ADDENDUM NUMBER 6

Project Number _____ Federal No. STBG-3001(007); City No. 89008525

Project Title N. Oak Trafficway Reconstruction – 42nd to 46th Street

ISSUE DATE: 07/09/2025

ROADWAY LIGHTING
 NEW PLANS

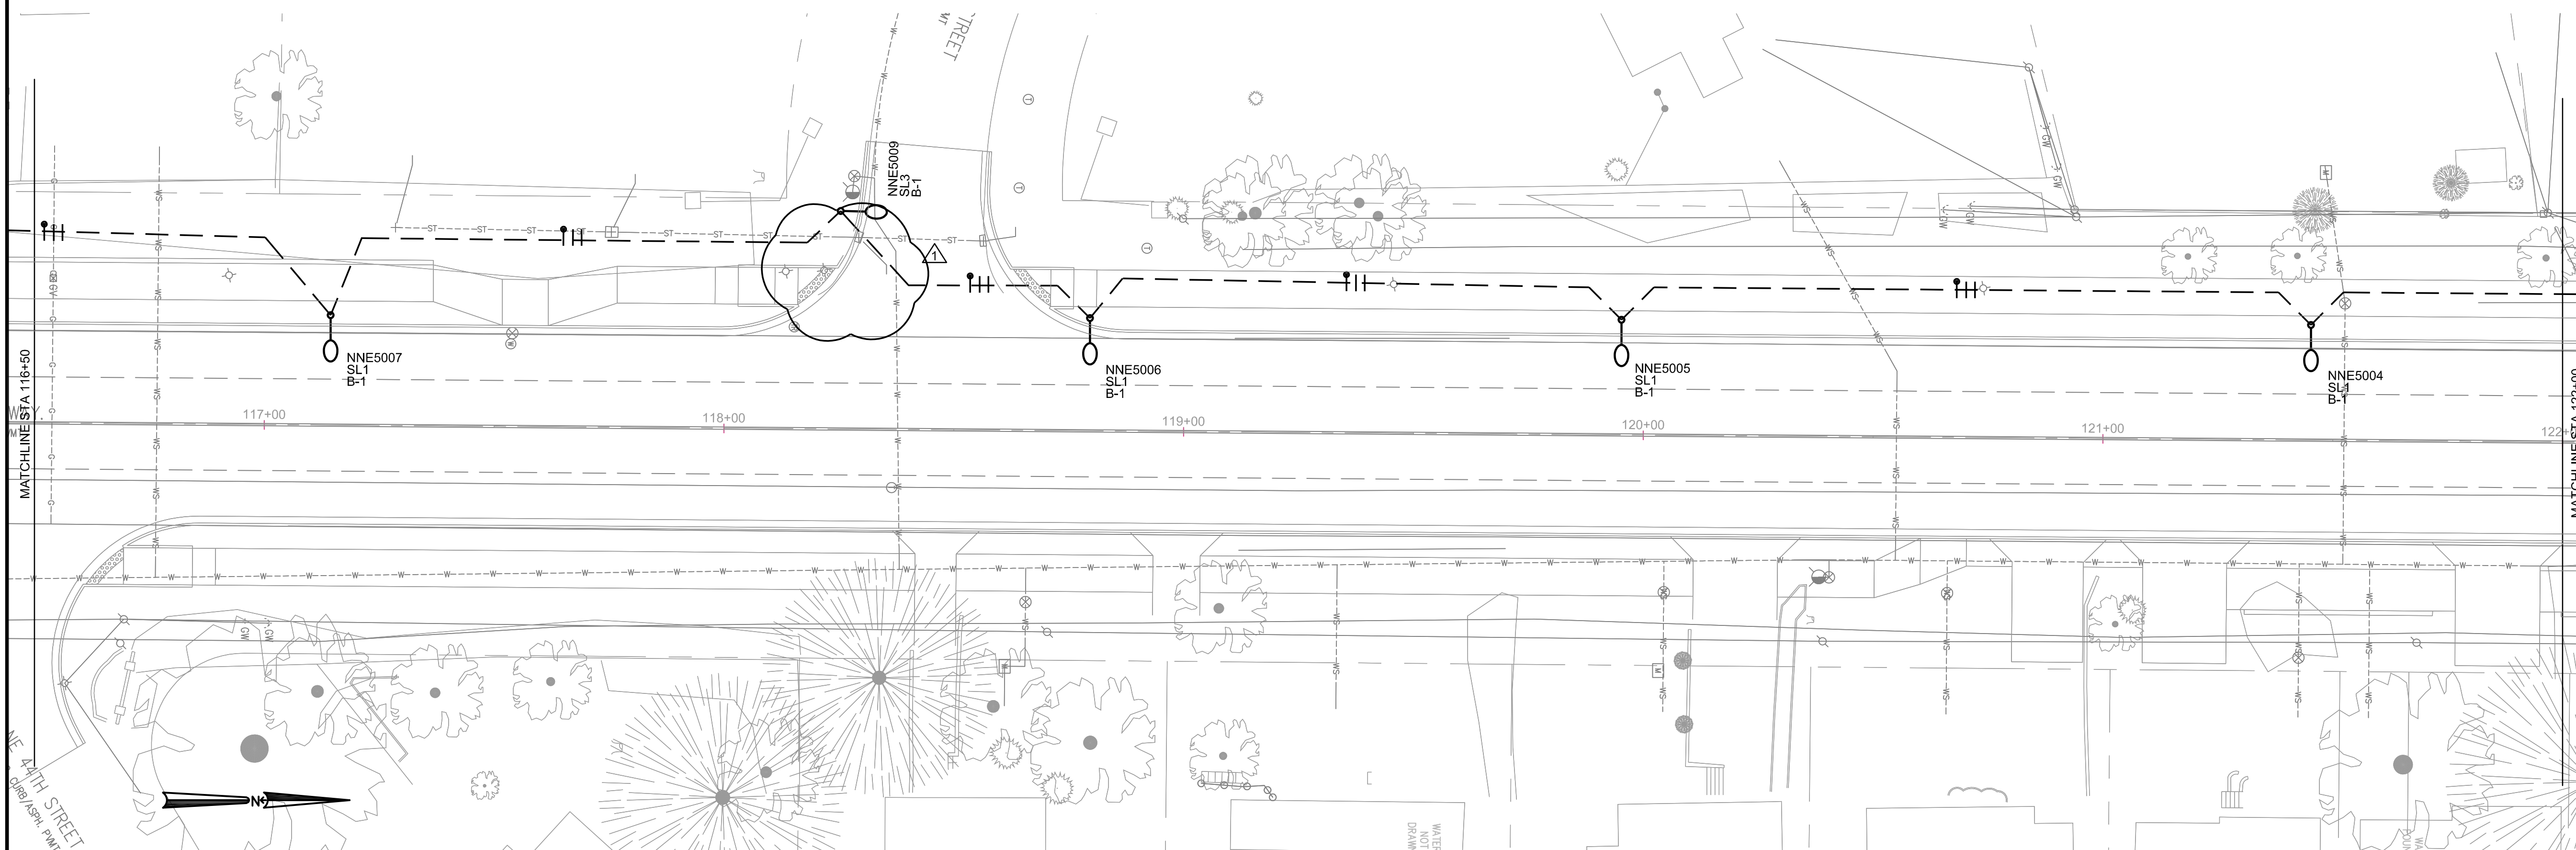
Q4	<ul style="list-style-type: none"> • Pole NNE5759 is listed on sheet 116 but nowhere to be found in the assembly quantity table on sheet 110.
A4	<p>The Assembly Quantity schedule has been revised to include this pole.</p>
Q5	<ul style="list-style-type: none"> • Pole NNE5010 is listed on sheet 118, but nowhere to be found in the assembly quantity table on sheet 110.
A5	<ul style="list-style-type: none"> • This pole needs to be a 40ft pole with a 15ft Truss. <p>The Assembly Quantity schedule has been revised.</p>
Q6	<ul style="list-style-type: none"> • New fixture SL3, screw-in foundation, and fuses are listed for Pole NNE0X53 on sheet 110 but I can't find if on the plan sheets.
A6	<p>The Assembly Quantity schedule has been revised to reflect the correct pole number of NNE5009, where previously shown as NNE0X53. The pole shown on the plan sheet 117, labeled as NNE0X53 XL, has been deleted.</p> <p>Pole NNE5008 shown on Sheet 117 has been revised to a Type SL3.</p>

2 6IN HELIX FOUNDATION DETAIL

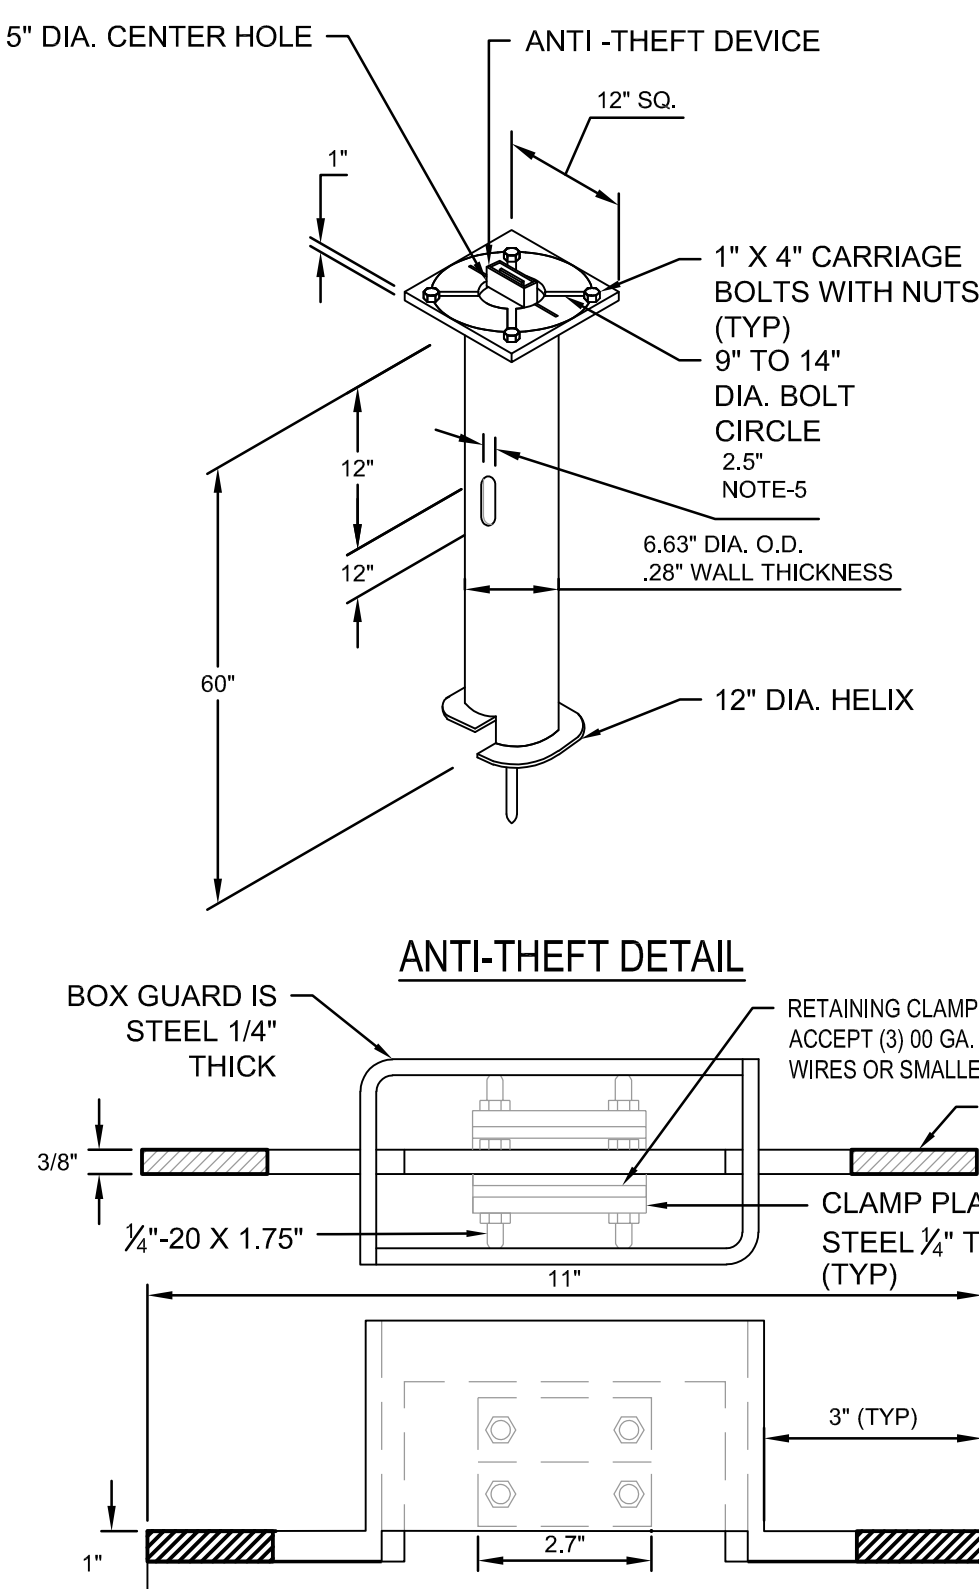
Q1	<ul style="list-style-type: none"> Line 75 calls for (QTY 19) Pole 35' Valmont Aluminum with 8' Truss Arm-Signal. Sheet 110 and 111 detail 40' poles with either 10' arms or 15' arms. What is needed?
A1	<ul style="list-style-type: none"> The 6" Helix with retainer foundation detail has been added for SH2, Sheet 110. The plans previously indicated a 40' pole mounting height per the Equipment List on Sheet 111. The plans also include both 10' and 15' arms. These are separated out in the Equipment List (Sheet 111), Assembly Quantity (Sheet 110), and the Photometric Plans (Sheets 124). The Summary of Quantities descriptions have been revised.
Q2	<ul style="list-style-type: none"> Sheet 110 indicates some poles have both 10' and 15' arms (ex: NNE5003) but display only one arm on the plan sheets. What is correct?
A2	<ul style="list-style-type: none"> The Assembly Quantity Schedule (Sheet 110) has been revised to reflect the 10ft and 15 truss arms. Additional details for the 30ft Valmont pole and the 6" Helix with retainer foundation have been added to Sheet 110.
